# UNITED STATES PATENT AND TRADEMARK OFFICE

10/588,775

Yasuhiro Okamoto

<b>Office Action Summary</b>	Application No. 10/588,775	Applicant(s) OKAMOTO ET AL.	
	Examiner Meiya Li	Art Unit 2811

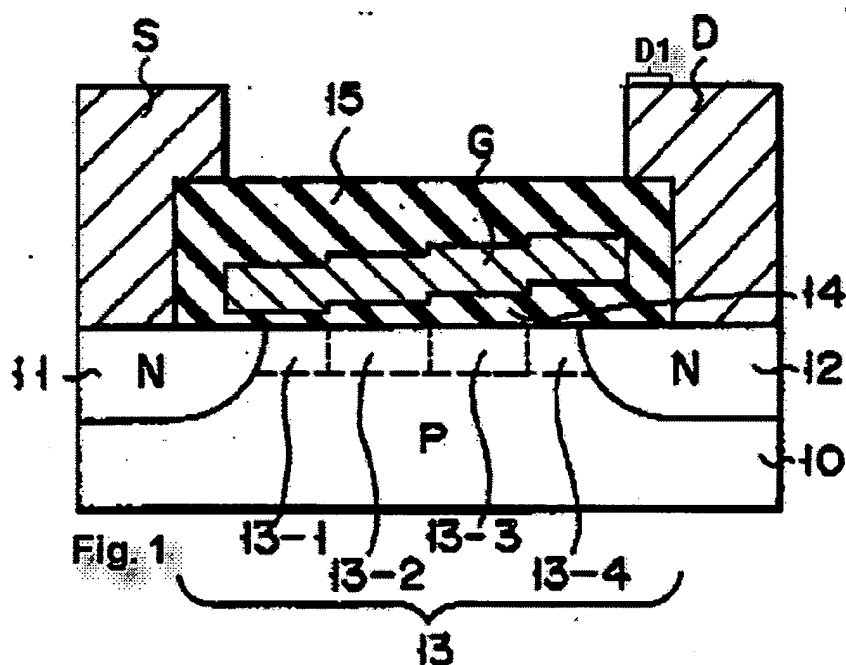
As for claim 1, Shur et al. shows (Fig. 5) a field effect transistor 220 comprising a III group nitride semiconductor layer structure 212/214 including hetero junction ([0025], lines 6-8 and 15-17; [0033], lines 5-6), a source electrode 224 and a drain electrode 226 that are so formed on said semiconductor layer structure 214/212 as to be separated each other, a gate electrode 222/230 formed between said source electrode 224 and said drain electrode 226, and an insulating film 218 formed on said semiconductor layer structure 214/212, characterized in that said gate electrode 222/230 has a field plate portion 230 that projects to said drain electrode 226 in the form of an eave and that is formed on said insulating film 218.

However, Shur et al. fails to show a thickness of a portion of said insulating film lying between said field plate portion and said semiconductor layer structure gradually increases from said gate electrode toward said drain electrode.

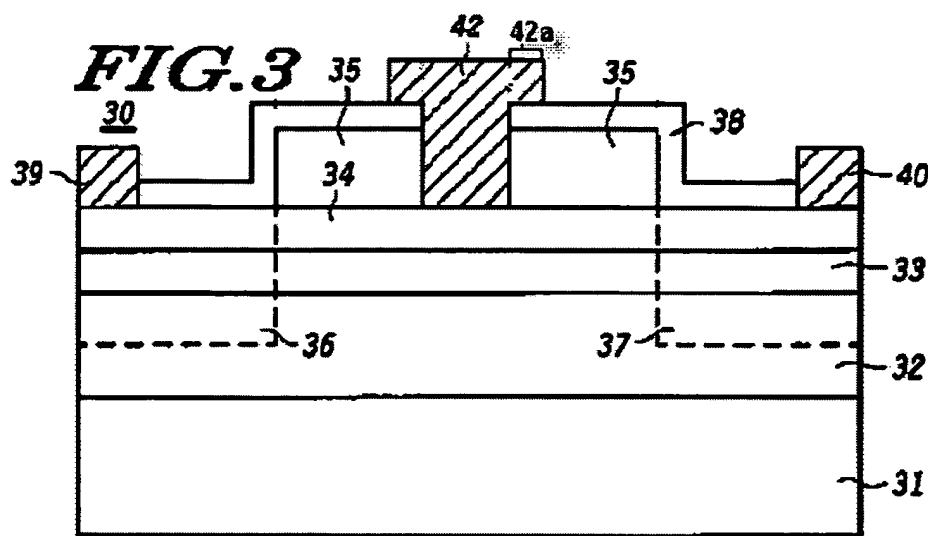
As for claim 1, Martinez et al. show (Fig. 3) a field effect transistor 30 comprising a III group nitride semiconductor layer structure 32/33/34 including hetero junction ([0016], line 2; [0030], line 23-25), a source electrode 39 and a drain electrode 40 that are so formed on said semiconductor layer structure 32/33/34 as to be separated each other, a gate electrode 42 formed between said source electrode 39 and said drain electrode 40, and an insulating film 38 formed on said semiconductor layer structure 32/33/34, characterized in that said gate electrode 42 has a field plate portion 42a that projects to said drain electrode 40 in the form of an eave and that is formed on said insulating film 38.

However, Martinez et al. fails to show a thickness of a portion of said insulating film lying between said field plate portion and said semiconductor layer structure gradually increases from said gate electrode toward said drain electrode.
